Special Bulletin

SP18-24

BELLEVILLE WASHER ADDITION ON SLIDE-OUT

Prevost vehicles

Figure 4: Leveling screws

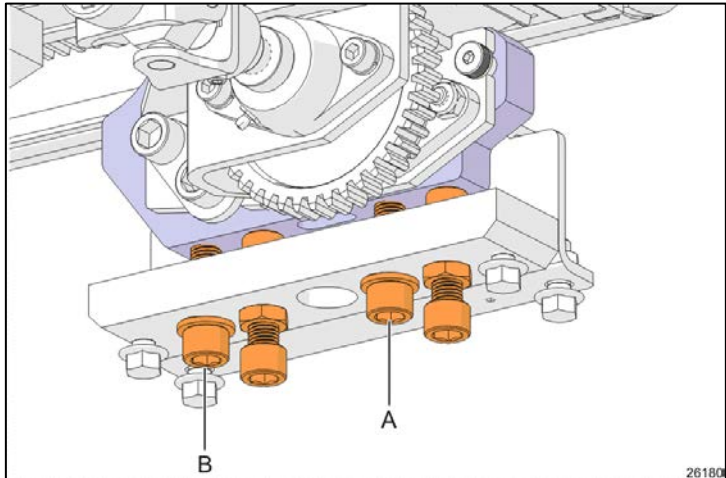
4. Remove screw **A** (Figure 4).
5. Add missing washer 5002082.
Tighten to **55-65 lb-ft (75-88 Nm)**
6. Remove screw **B** (Figure 4).
7. Add missing washer 5002082.
Tighten to **55-65 lb-ft (75-88 Nm)**
8. Re-install access hatch and seat.
